CRIME IMPACT STATEMENT

Fernhill Gypsy and Traveller Site Redevelopment of the travellers' site

for: Bury Council

URN: 2021/0061/CIS/02

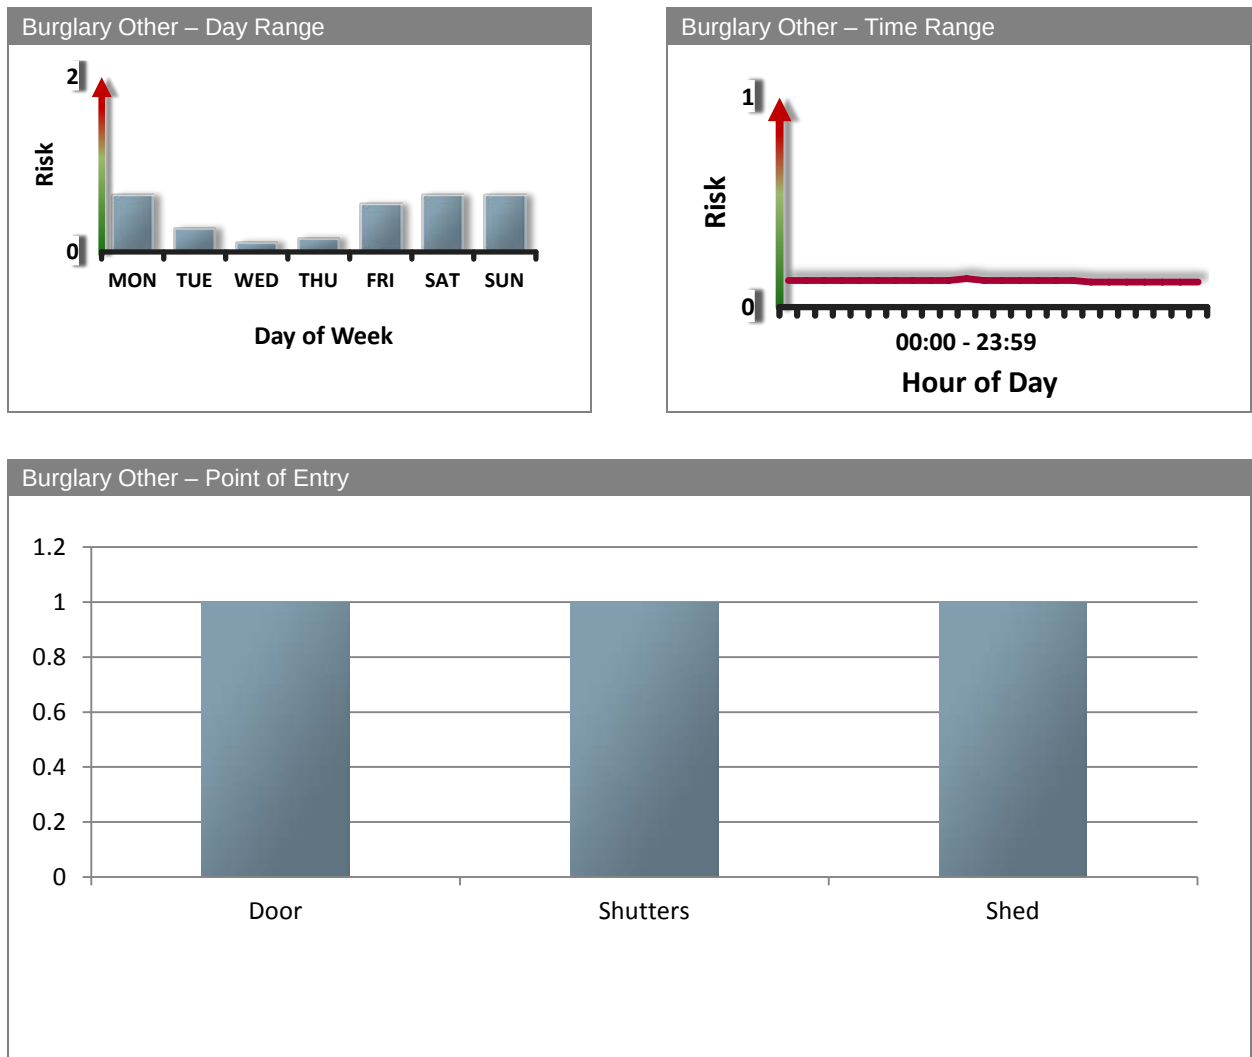
- 2.2.2 Exploitation of insecure boundary fencing and gaining access to outhouses / sheds using bodily pressure and implements.

- 2.2.3 Criminal damage to vehicles, by means of smashed glazing and scratched paint work.

Possible Solution – All boundary fencing and gates should be checked regularly to identify any defects or damage with any necessary repairs carried out promptly. Fencing should be protected from potential damage from vehicle movements, using kerbing or crash barriers. There should be no climbing aids that could provide a step over the fence line, either insider or outside the site boundary. Overhanging vegetation should be cut back away from the fence line.

Possible Solution – Parking spaces for vehicles within the site should be located away from main pedestrian routes or communal space. Parking spaces should be capable of being overlooked from properties, and covered by any CCTV on the site. Individual plots should be well defined, with implicit territorial statements to divide communal and more private space, with adequate parking space provided within the plot. Avoid any on-site storage of loose materials that could be used to cause criminal damage.
